SAFETY RECALL RVXX0603

SAFETY RECALL BULLETIN

SUBJECT: Disc Wheel Spacer

Fig. 1: Typical Wheel installation

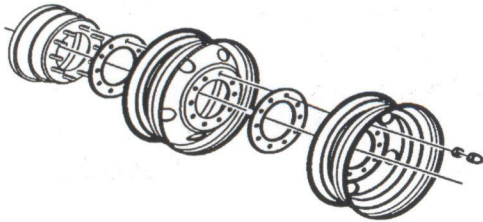
3. Remove the wheel spacer installed between disc wheels and between the inner disc wheel and brake drum.
4. Inspect the disc wheel, wheel studs, and wheel nuts for damage.
5. Install the new wheel spacers PN 8164670 between inner disc wheels and brake drum on dual wheels.
6. Reinstall the outer disc wheel with the new wheel spacer PN 8164670 between the inner and outer disc wheel. Torque the wheel nuts in a crossing pattern to 645 ± 35 Nm (475 ± 25 ft-lb).
